# CITY PLANNING COMMISSION

- APPLICATION:
- A. Negative Declaration
  - B. Rezone 2.9+ vacant acres from Two-Family-Review (R-2-R) to the Multi-Family-Review (R-2A-R) zone to develop 24 apartment units.

LOCATION: Northwest corner of Broadway and Fairground Drive

PROPOSAL: The applicant is requesting the necessary entitlements to develop 24 family residence apartments.

# SITE PLAN

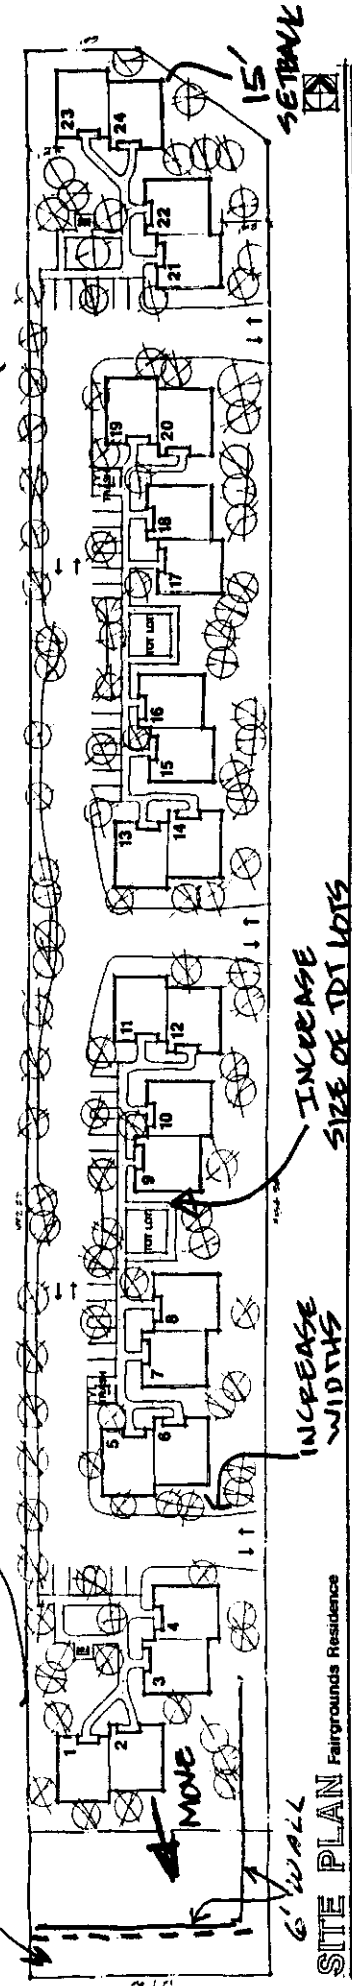
The submitted site plan indicates 12 buildings, each a duplex unit with 1,850 square feet per building, i.e. each dwelling unit is 925 square feet. The buildings are clustered into four groups with driveways leading back to rear parking areas from Fairgrounds Drive. No parking area will be directly visible from either Fairgrounds Drive or Broadway. The original submitted site plan proposed to split off a front 9,000+ square foot lot for future sale. Staff has recommended to the applicant that this front lot along Broadway be incorporated into the overall project. Staff sees no justification to separate this lot out and leave vacant. By incorporating this added area to the project the overall site plan is improved. Staff suggests a 25 foot landscape setback along Broadway. This landscape setback should include a 3-1/2 foot high undulating turf berm with clusters of trees. the remaining 50+ feet should be used to spread out the entire project including increasing the size of the lot, increasing the landscape area between driveways and structures and maintaining a minimum 15 foot landscape setback at the rear of the property. These recommendations will give much better use of the additional front lot area and add to the integration of the project in terms of open space and privacy. Staff also suggests a 3-1/2 foot turfed berm with trees along Fairgrounds Drive. The applicant should submit a revised site plan and landscape plan incorporating staff's suggestion for review and approval by planning staff prior to issuance of building permits.

In addition, staff suggests a six foot high decorative masonry wall be installed 25 feet back and parallel to Broadway and Fairgrounds Drive (see site plan). This will mitigate noise from Broadway and screen the back end of the structures.

1. The applicant shall submit a revised site plan to planning staff for review and approval prior to issuance of building permits. The revised plan should include the following:
  - a. incorporate the front lot into the overall project (eliminate proposed parcel line);

- b. provide a 25 foot landscape setback along Broadway;
  - c. spread out the entire project, providing more open space;
  - d. maintain a 15 foot building setback along the north property line;

- e. increase the width of landscape area between driveways; and
  - f. increase the size of the tot lots.
2. The applicant shall submit a detailed landscape plan to planning staff for review and approval prior to issuance building permits. Landscape plan should include the following:

SPREAD OUT ENTIRE PROJECT TO PROVIDE ADDITIONAL OPEN SPACE

25' LANDSCAPE SETBACK

6' WALL

INCREASE SIZE OF IDI LOTS

INCREASE WIDTHS

15' SETBACK
